RE: **1105 Yale Blvd SE**
Grading Plan
Engineer's Stamp Date: 7/23/18
Hydrology File: L15D062

Based on the submittal received on 7/23/18, the Grading Plan cannot be approved until the following are corrected:

**1105 YALE BLVD., SE
GRADING PLAN**

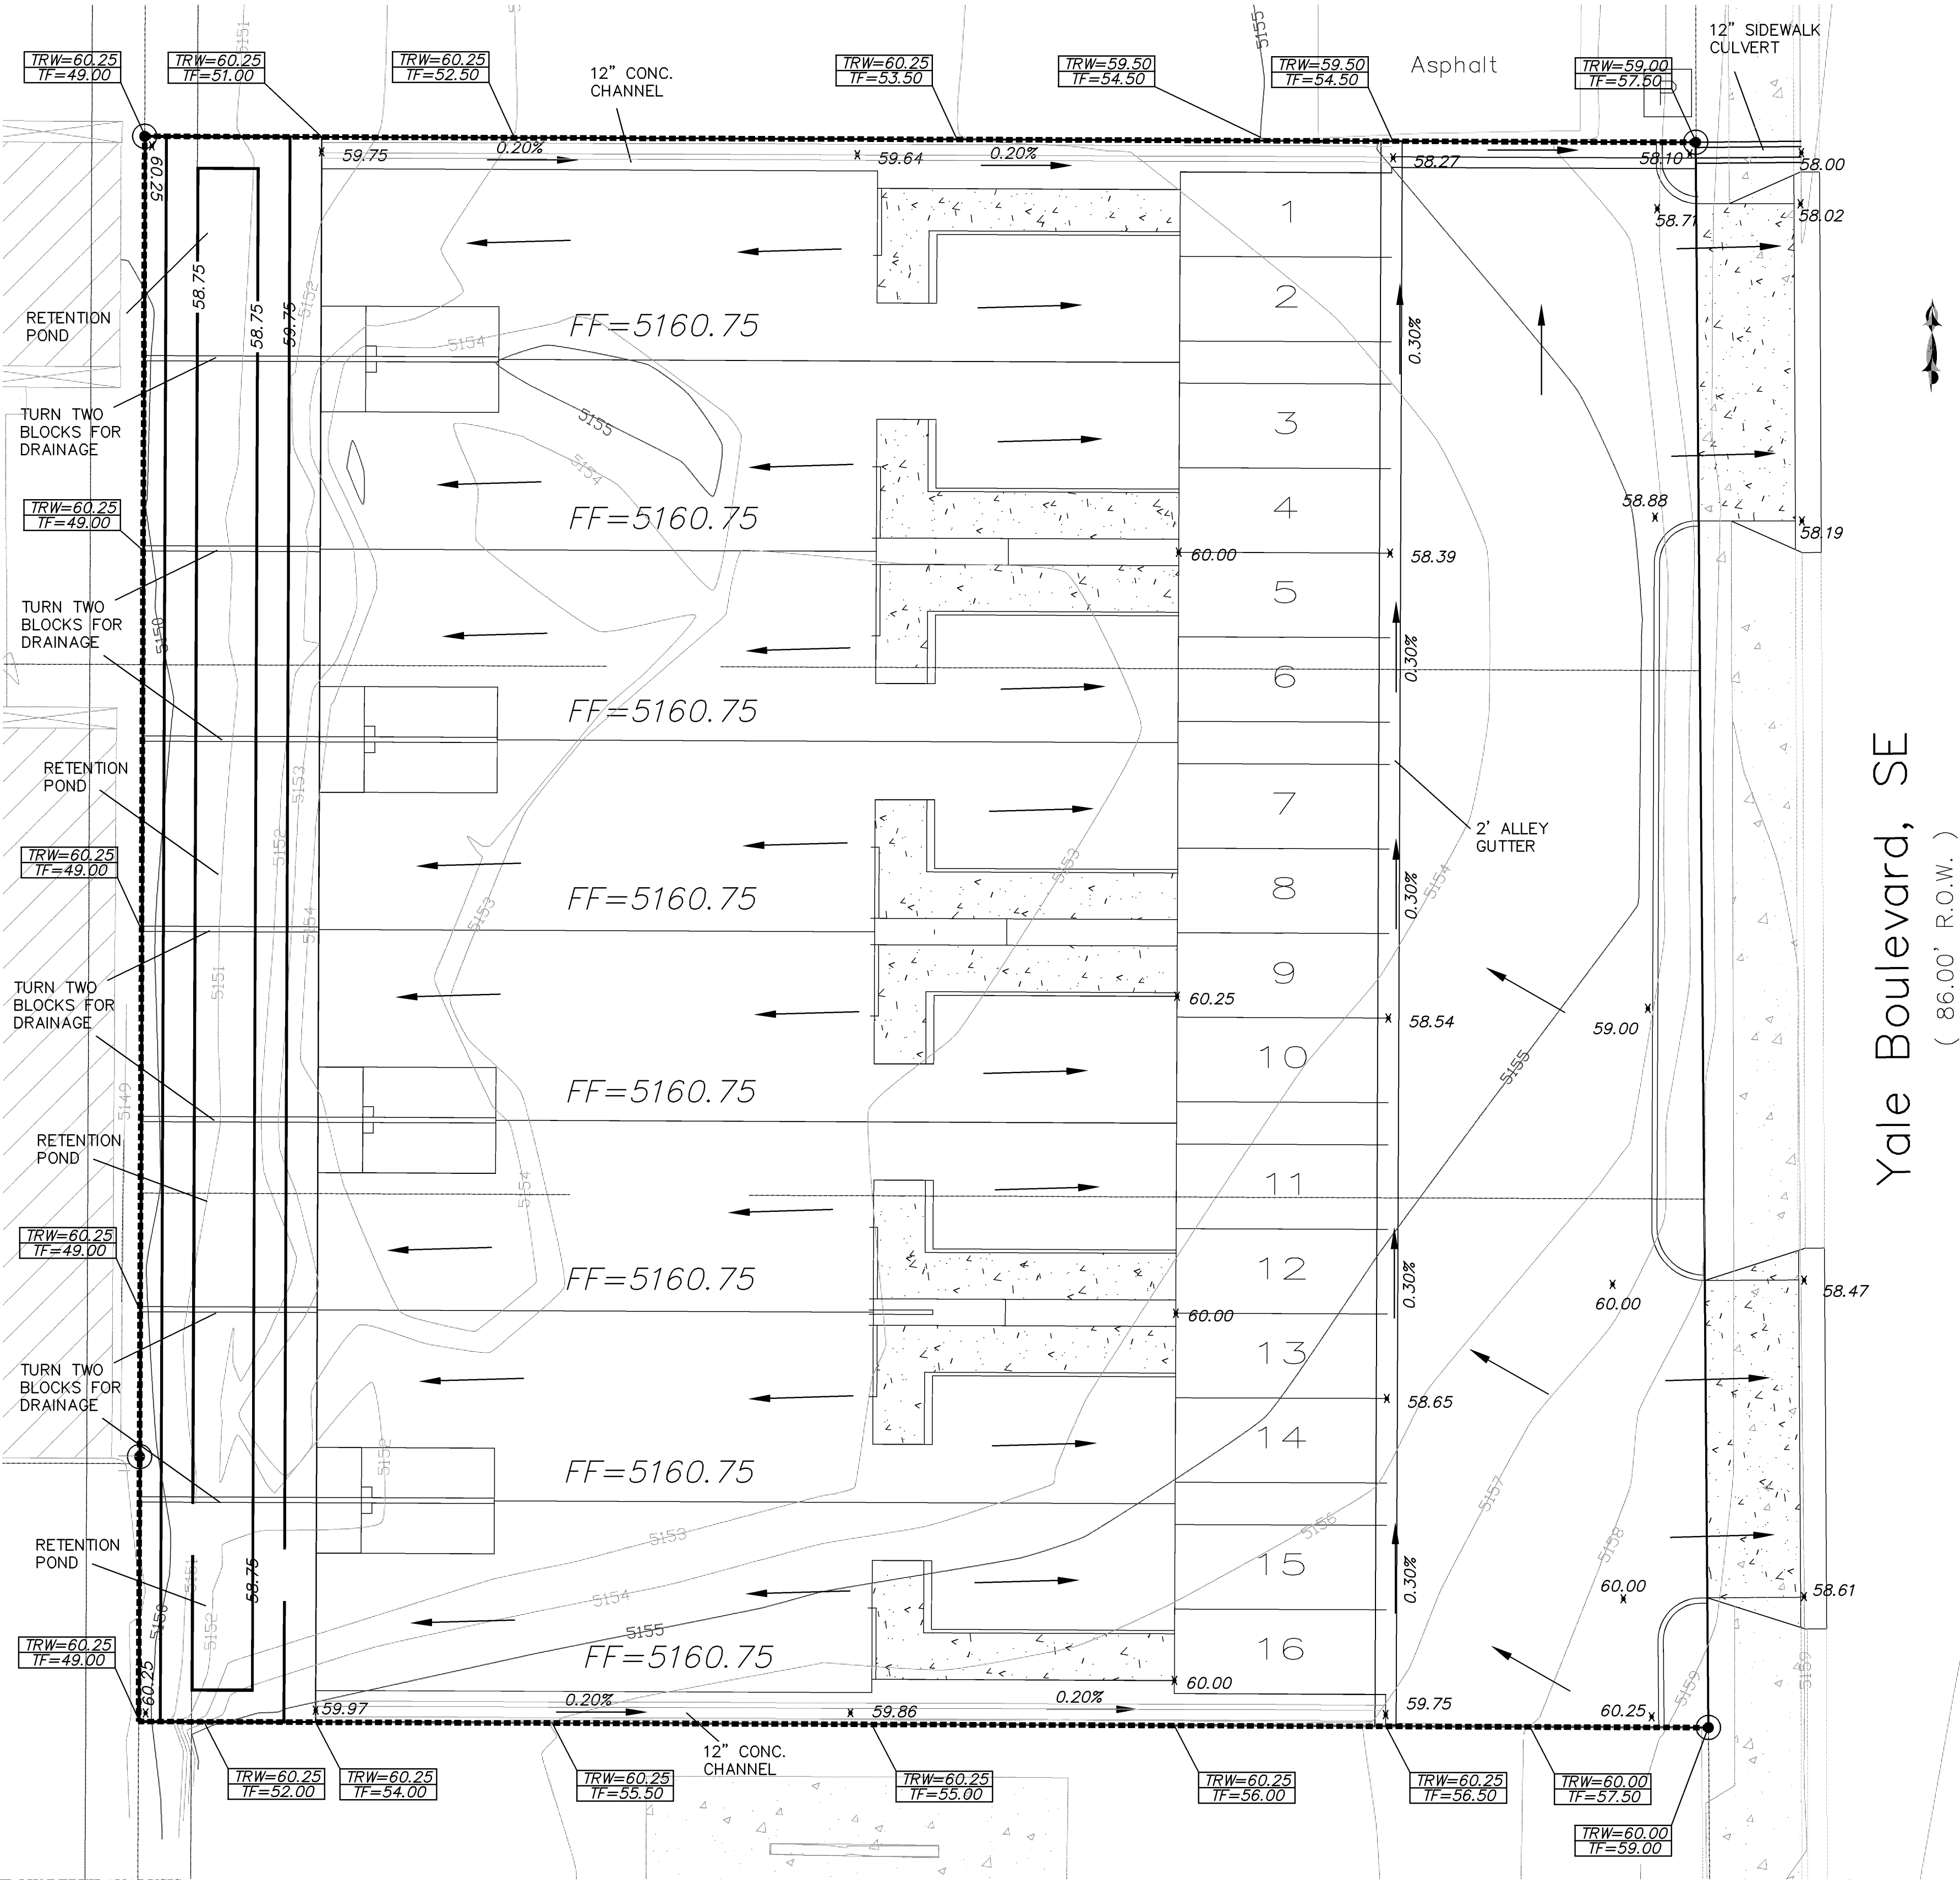
1. The site must demonstrate adequate downstream capacity per § 14-5-2-12(G) of the Albuquerque Code of Ordinances. This property has never drained to Yale and its runoff was not anticipated in sizing infrastructure on Yale. This property will likely have to retain all runoff on-site (100-yr, 10 volume) or obtain a drainage easement from a neighbor to drain south or east.

2. Provide wall sections for all cases around this property. Show property lines, walls, footers, horizontal and vertical dimensions, and existing and proposed elevations on both sides of the walls. In accordance with DPM Ch.22, section 5 part B, grading and wall construction near the property line may not endanger adjacent property or constrain its use.

3. Provide structural details for the wall on the west property line. This wall will need to be designed for saturated conditions due to its proximity to the pond. Also show the maximum water surface elevation and provide 2.0' (minimum) freeboard around the pond.

4. Consider the constructability of a channel on a 0.2% slope. This will need to be surveyed as part of the Engineer's Certification and ripped out and replaced if not able to drain per plan.

5. The concrete channels need to provide 1.0' (minimum) of freeboard and manning's n for poured concrete is 0.13. The channel is sized as an 18" wide channel, but called out in plan view as 12" wide.

6. If the sidewalk culvert is to be built, an SO-19 Permit will be required and should be included on the request. Please include the [standard SO-19](#) notes on the grading plan.

7. Add note on the plan that “No work shall be performed in the public ROW without an approved Work Order or Excavation Permit.”
8. A [Drainage Covenant \(No Public Easement\)](#) is required for the stormwater control pond. The original notarized form, exhibit A (legible on 8.5x11 paper), and recording fee (\$25, payable to Bernalillo County) must be turned into DRC (4th, Plaza del Sol) for routing. Please contact Charlotte LaBadie (clabadie@cabq.gov, 924-3996) or Madeline Carruthers (mtafoya@cabq.gov, 924-3997) regarding the routing and recording process for covenants.

9. Provide a subbasin delineation map and define the areas of impervious cover. First flush retention ponds must capture runoff from the impervious areas and the ponds must be sized for the areas draining to them. If unable to capture the first flush runoff, quantify the first flush bypass volume and state on plans. Payment of the Fee in Lieu (Amount = BypassVolume x \$8/cf) will then be required.
